NOTICE OF PROPOSED CHANGE IN PROPERTY

Petition: x1388

B					REQUEST TO CONVERT TO EASEMENT A PORTION OF CASS AVE. VARIOUS WIDTH SPROAT AND SIBLEY ST. 50 FT. WD., A PORTION OF HENRY ST. 50 FT. WD. AND CLIFFORD ST. 60 FT. WD. IN THE AREA BOUND BY CASS, TEMPLE, WOODWARD AVE. AND FISHER FWY. SERVICE DRIVE	CITY OF DETROIT	
A						CITY ENGINEERING DEPARTMENT	
DESCRIPTION		DRWN	CHKD	APPD		DATE	SURVEY BUREAU
REVISIONS						JOB NO. 01-01	
DRAWN BY	ICG	CHECKED				DRWG. NO. X 1388	
DATE	02-02-17	APPROVED

Date: March 3, 2017
To: Michael Marks
From: Aaron M. Balch
Subject: DTE Work related to LC Arena Cass Entrance Ramp (City of Detroit Petition 1388)

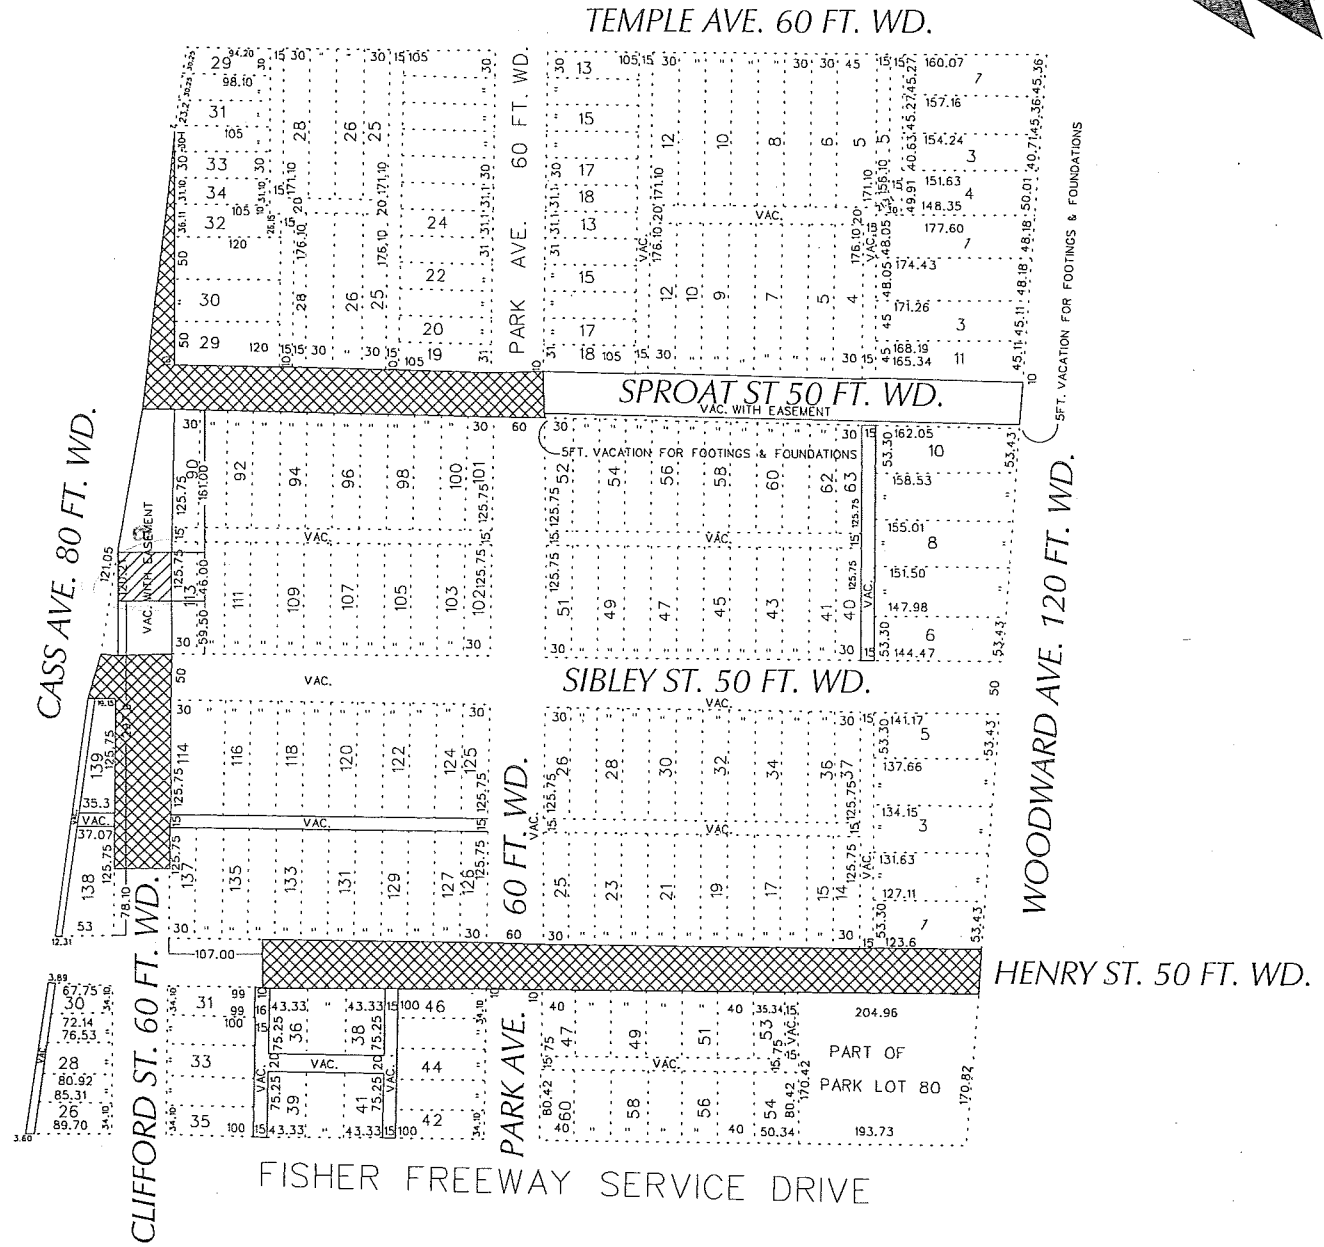
This is a method of service to shore up existing DTE Energy Electric conduit in Clifford St. +/-120' of existing conduit will need to be re-encased to provide adequate support for the proposed excavation and ramp footings to be constructed. DTE will also install (4) additional conduit sleeves the length of excavation prior to re-encasement since future construction will not be possible. DTE also requires dimensioned profiles of future elevations of the proposed ramp and grade relative to DTE infrastructure. Any DTE conduit structure shall not be encased into the footing, but shall have a sufficient geo-foam filled window of 6" around said conduit structure thru the width of the footing. The DTE conduit shall also not be encased into the ramp deck, but shall be maintained at a sufficient depth below said ramp not to exceed a minimum of 6". The resulting depth between DTE conduit and ramp deck shall be engineered fill.

- Install +/-120' of 1x4" 5" PVC conduit sleeves
- Re-encase +/- 120' of
- 40 hours of Underground Technician time
